September 9, 2008

SUBJECT: SR-520, MP 11.8, XL-2028  
West Lake Sammamish Parkway to SR-202  
RWN Bridge – Wall RW-RWN4  
Addendum 3 to Geotechnical Design Recommendations

Figure E-2: Typical MSE Wall Section

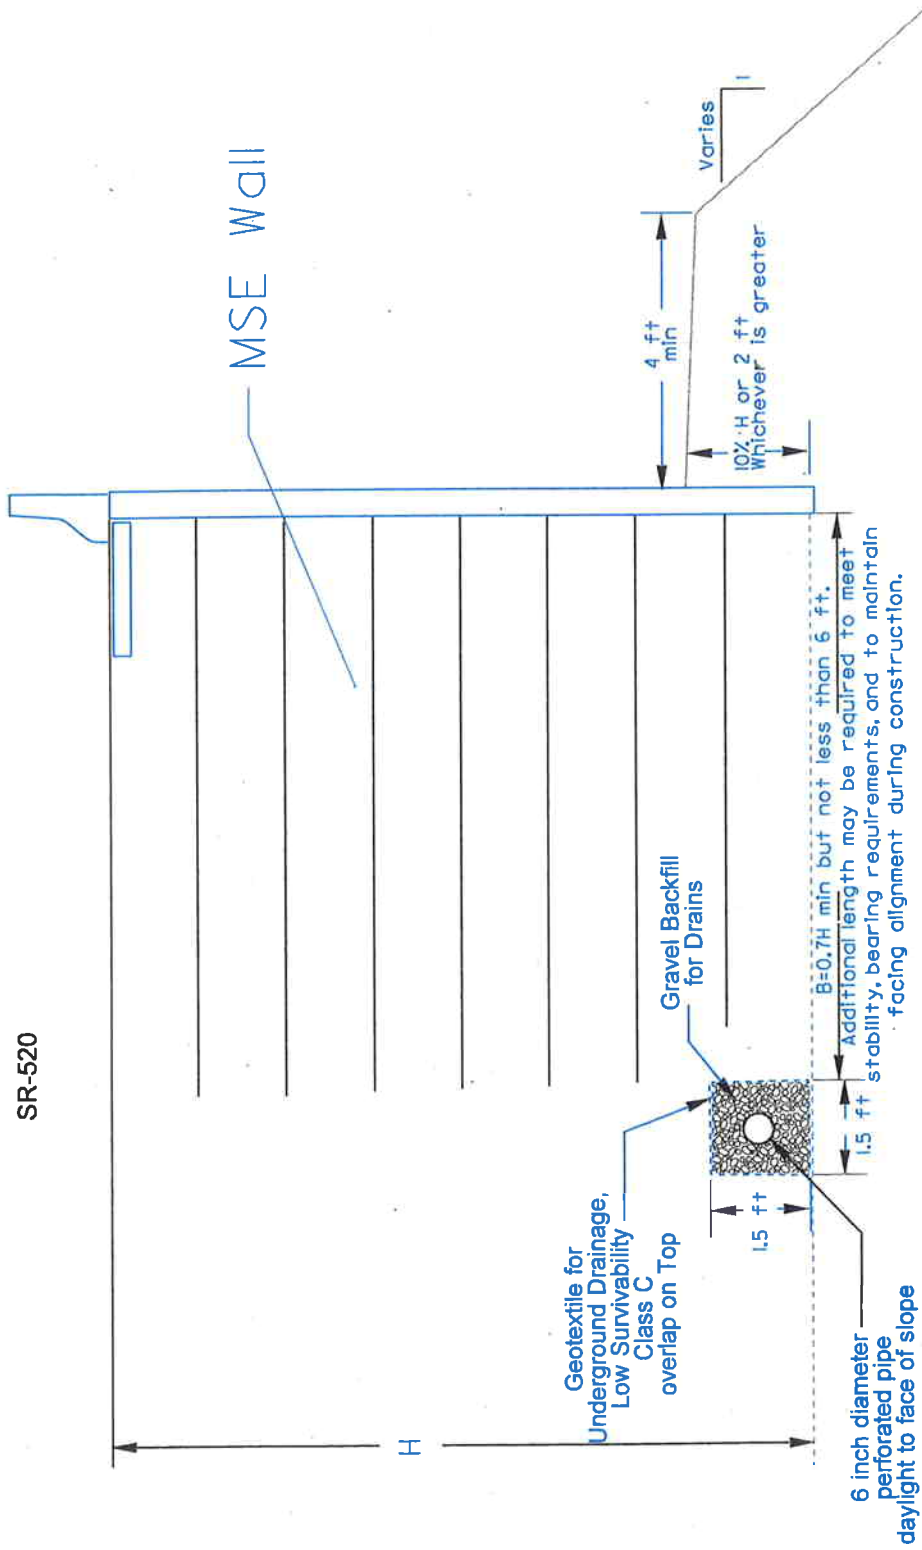
RWN-4 Wall will retain the new RWN Ramp east approach fill on the right side and will be constructed up to the Pier 5 curtain wall. A Structural Earth Wall is recommended to be consistent with the design of Wall RW-RWN3. For a Structural Earth Wall, Figure E-2 can be used to determine the minimum embedment requirements. A standard plan concrete is not recommended since the wall foundation will be within the Wall RW-RWN3 reinforcement zone.
